ADDENDUM NO. 03

Northland Corridor Redevelopment Project Phase 4
631 Northland Ave.
Buffalo, NY 14211

Project No. 432607

Project Northland Corridor Redevelopment Phase 4 (BUDC) Addendum No. 3
631 Northland Avenue, Buffalo, NY Contract -
Wendel Project No. 432607 Date 10/22/25

HM-100

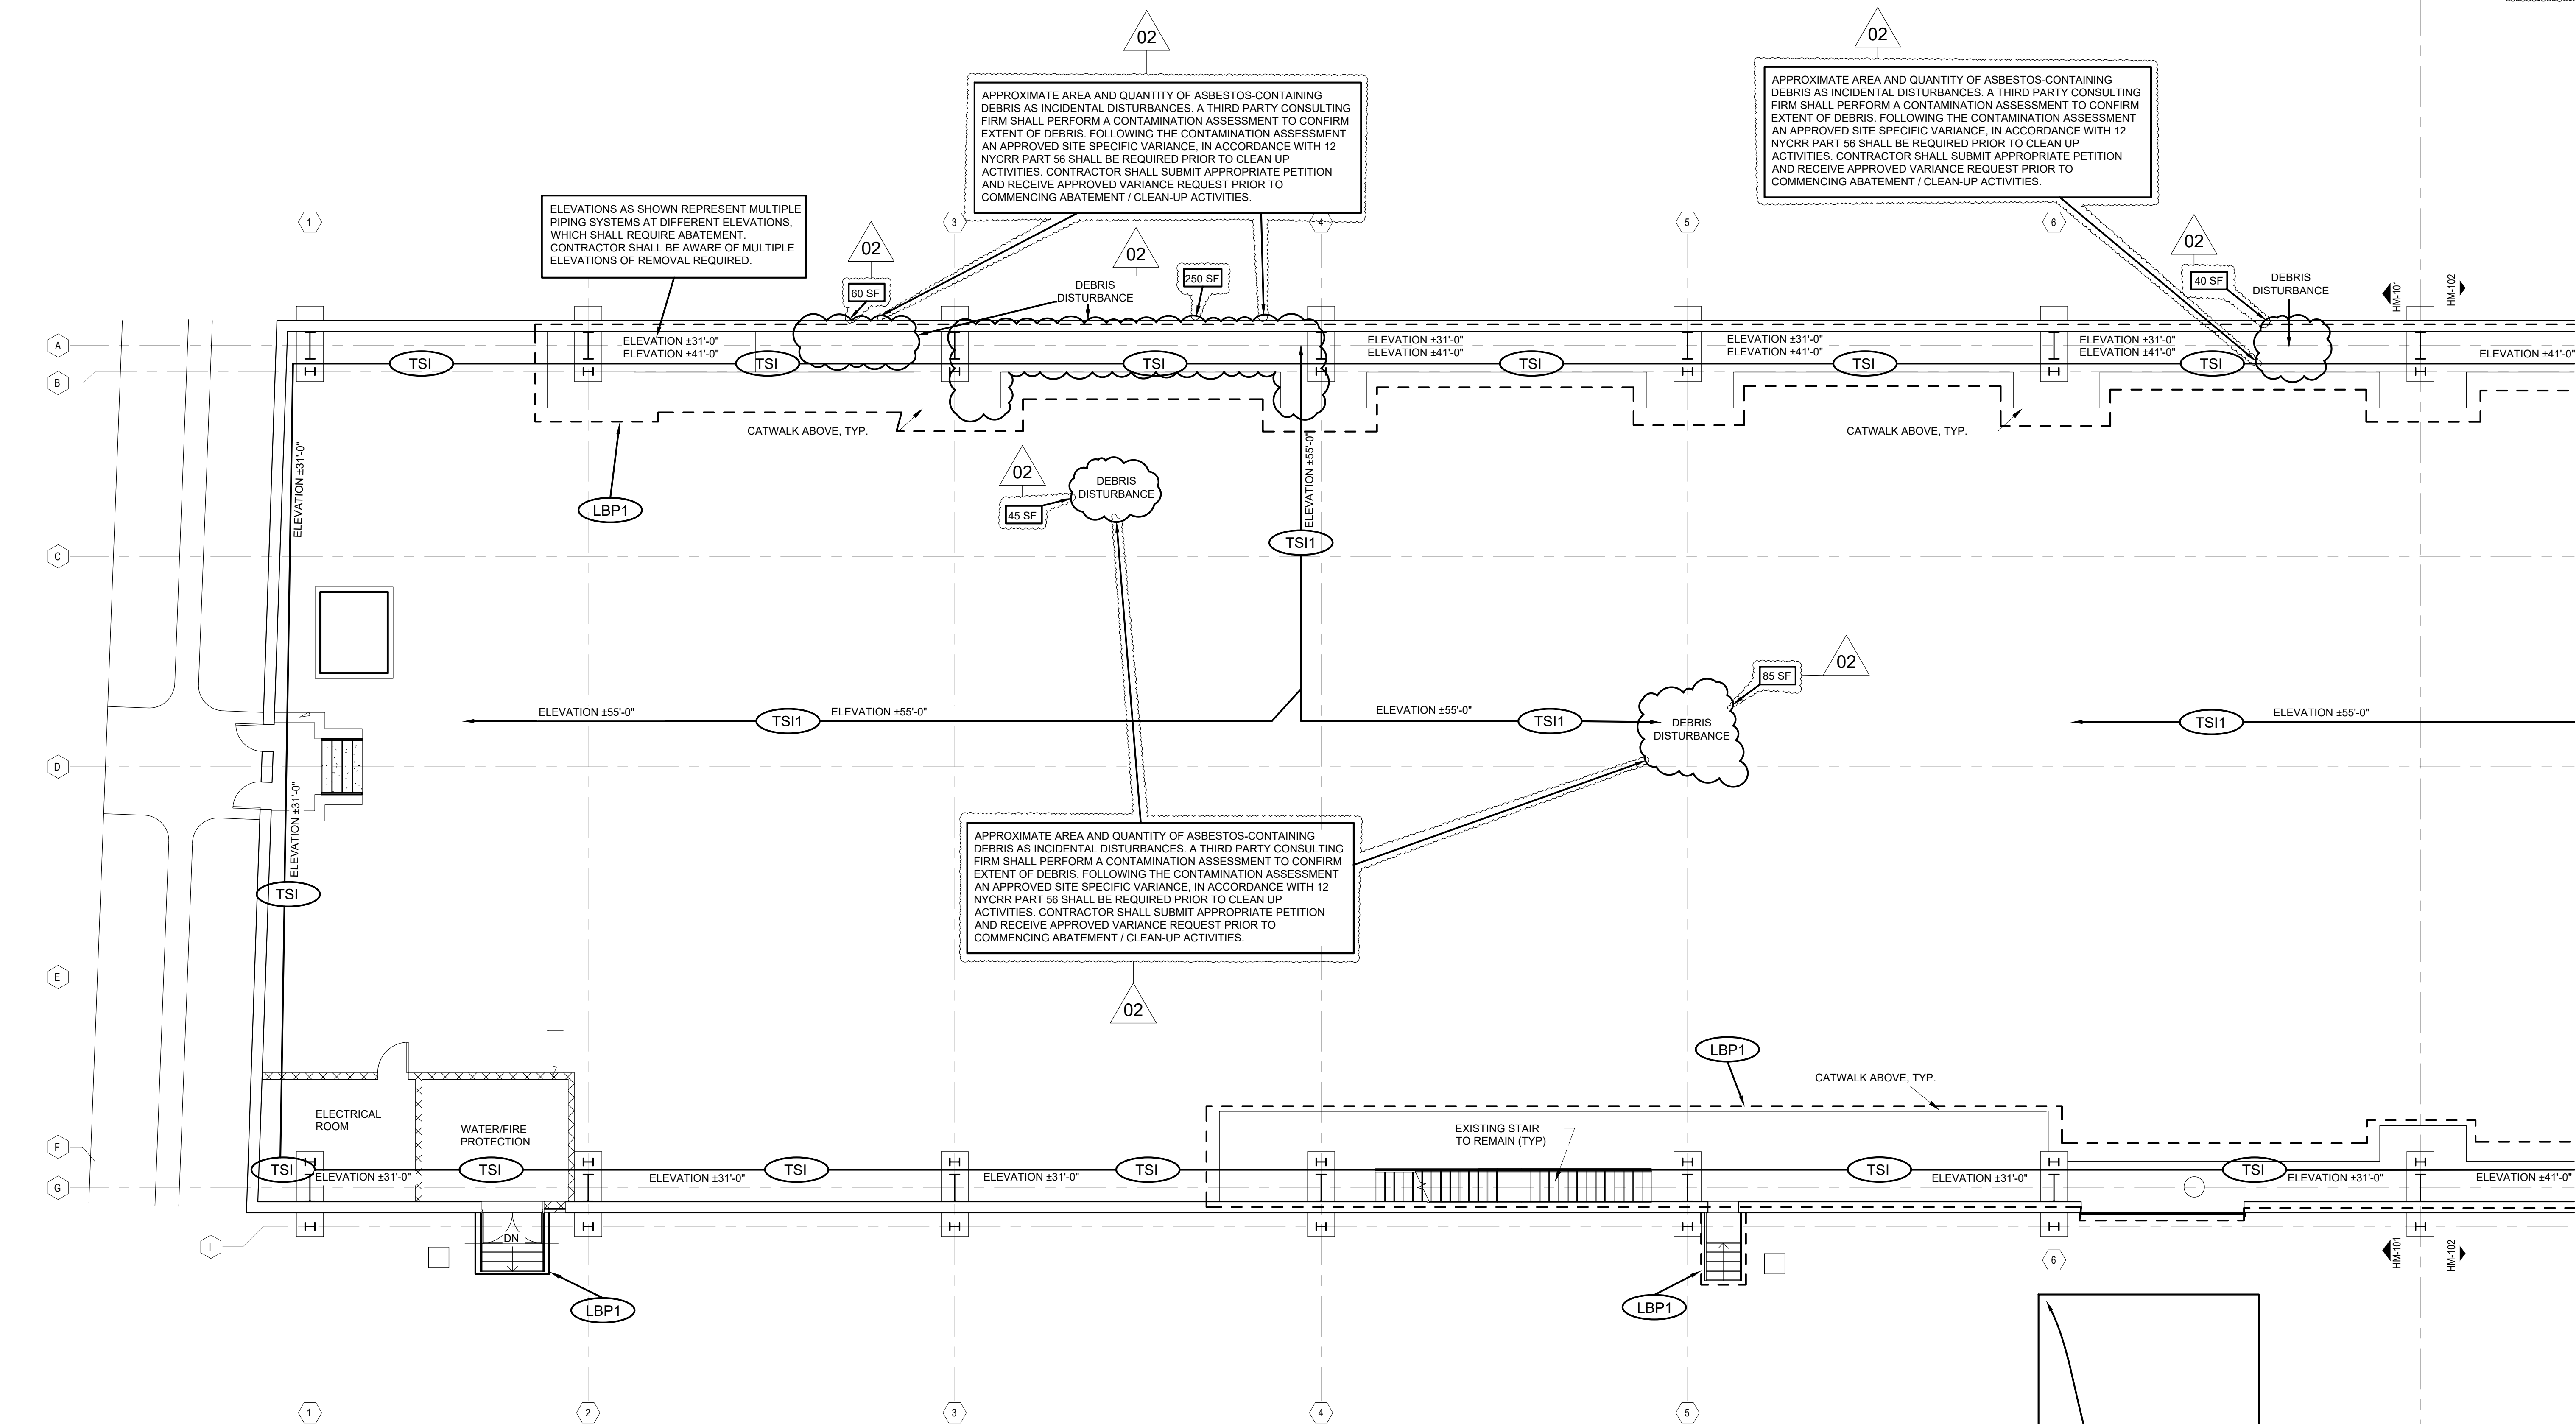
DELETE: HM-100, HM-101, and HM-102

CLARIFICATION: Hazardous materials incidental disturbance areas and linear feet have been clarified on the revised referenced drawings issued as part of this addendum.

ADD: Revised HM-100, HM-101 and HM-102 as issued in this addendum.

HM-101

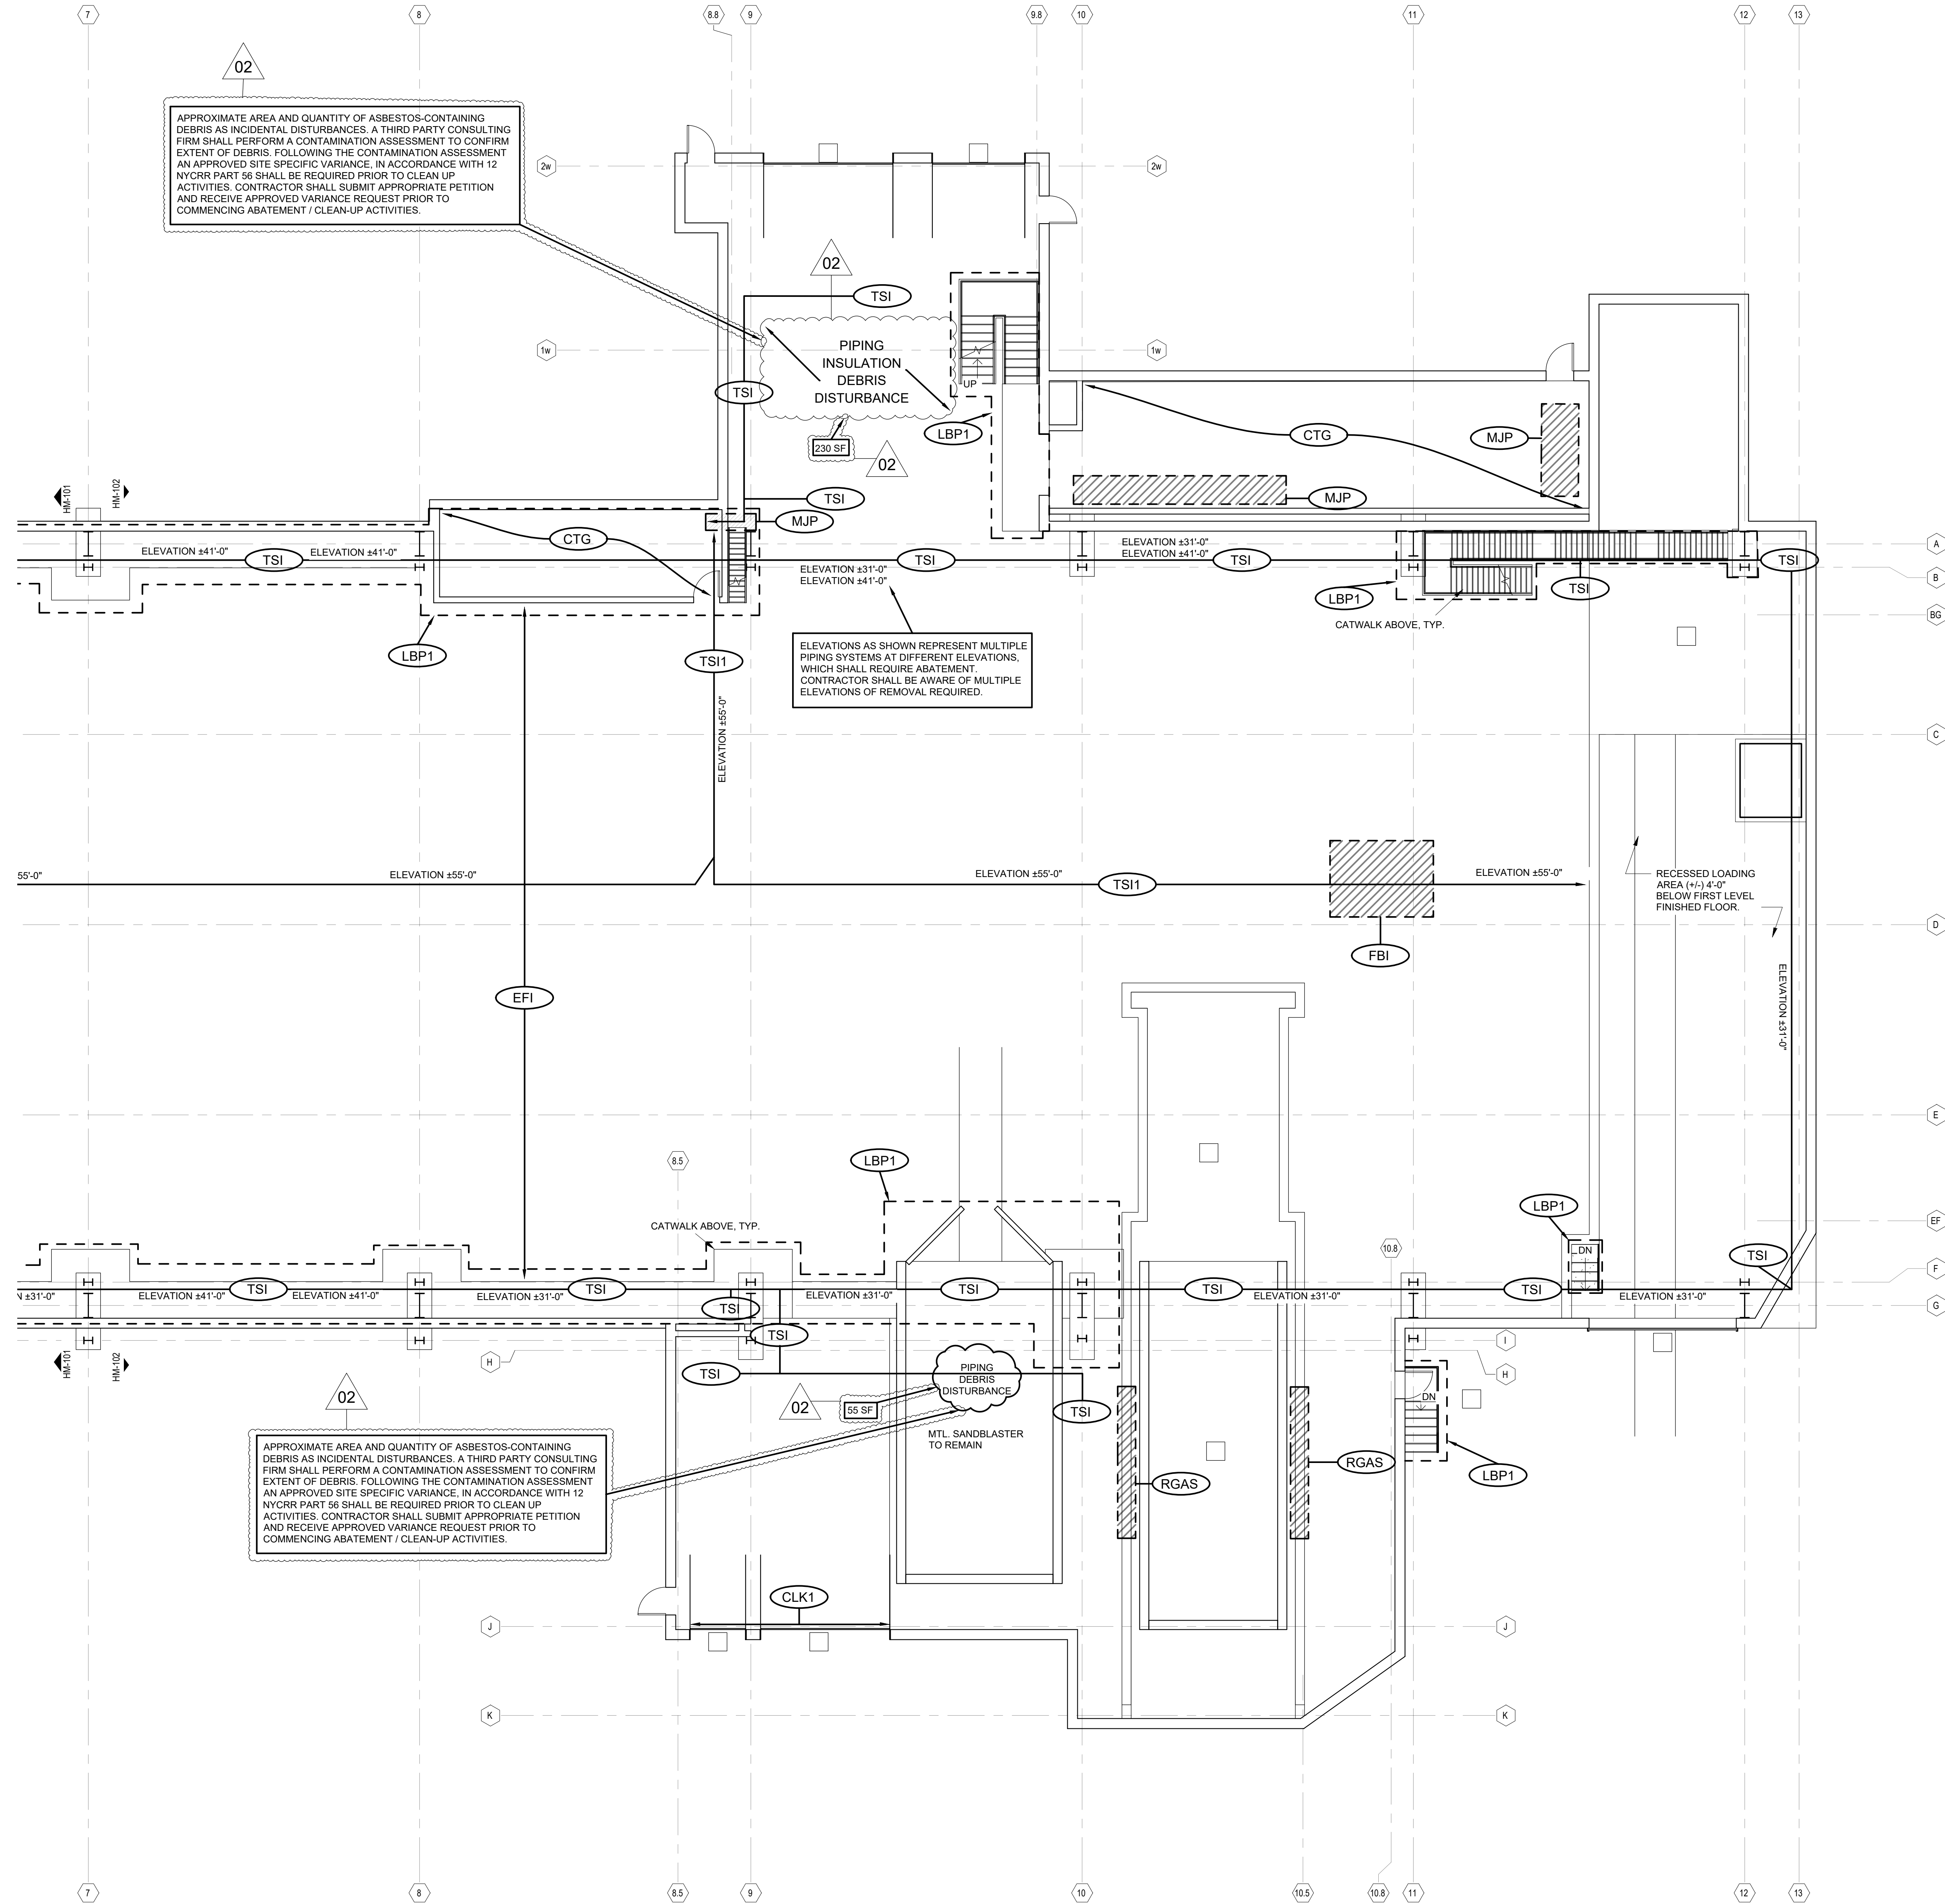
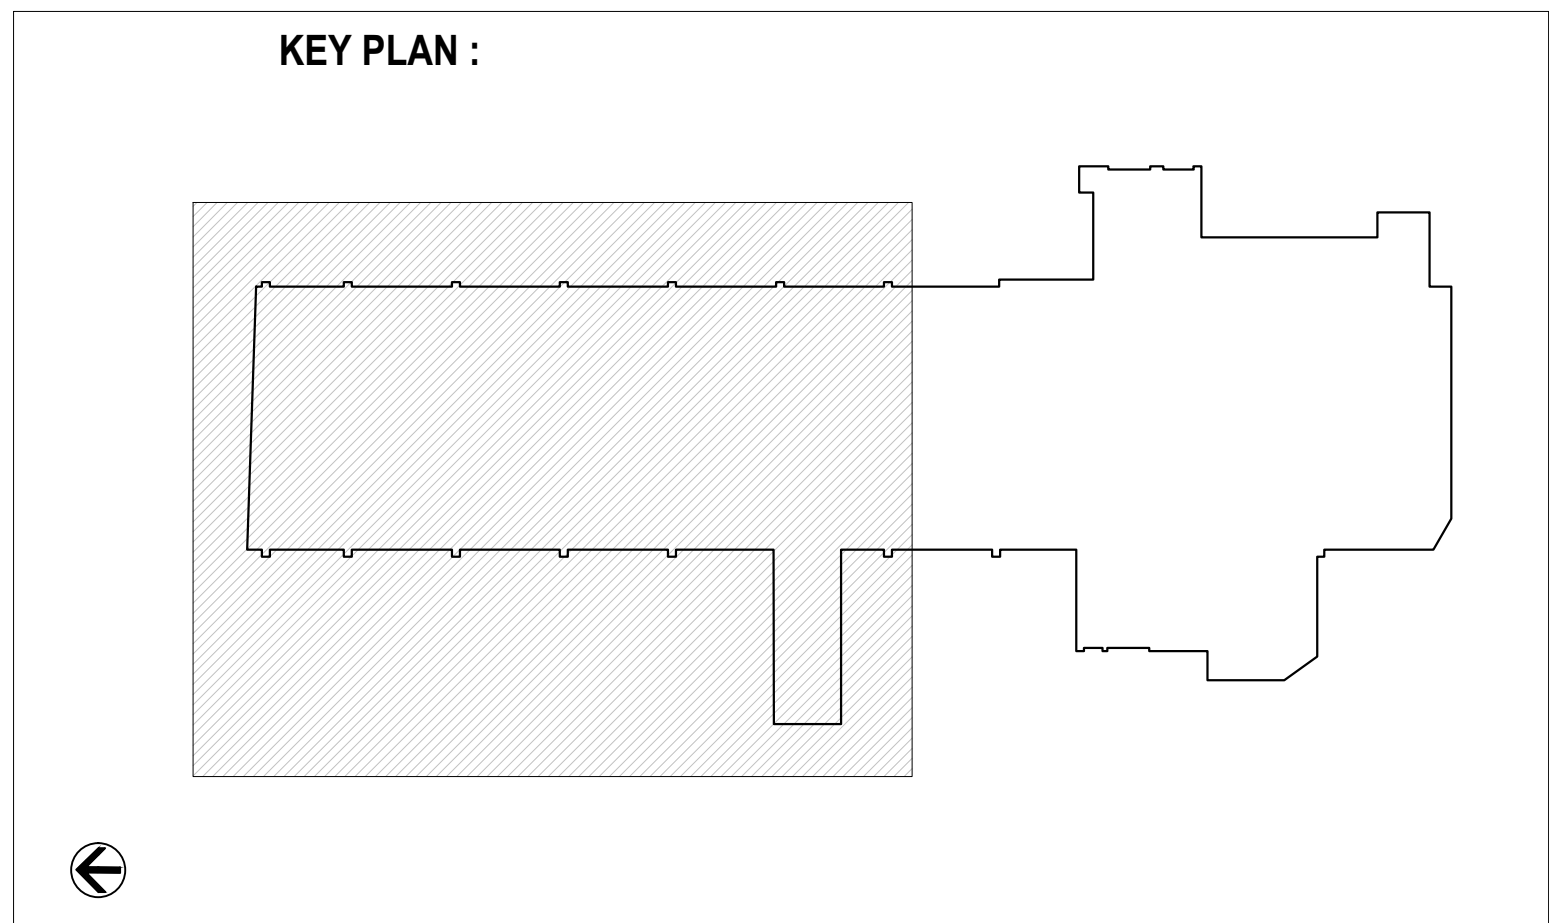
QUESTION: The HM drawing quantities show door caulk, electrical wiring, window caulk, window glazing, and mudded joint fittings in square footage. What was the conversion rate that was used to convert the quantities from linear footage to square footage as these items are usually shown as linear footage. For caulking it is normally 48 linear feet is equal to 1 square foot. For mudded fitting it is usually one fitting is equal to one linear foot what rate was used to convert it to square footage ?

ANSWER: In accordance with EPA Guidance RE&LS is limited to quantifying materials in linear feet to thermal systems insulation (piping, elbows, fittings) which do not exceed 12" diameter. As such, we have amended the quantities to show piping (MJP) as Linear Feet. The conversion rate used for MJP was equal to one fitting / elbow = one LF. For caulks / glazing associated with the windows, due to the number of layers present we accounted for one SF of material per window unit. For doors, due to multiple layers, we accounted for one SF per door. For electrical wiring insulation, we measured the assumed distance and took the width of the insulation to determine the quantity provided. Please refer to revised HM100 – 102 in this addendum.
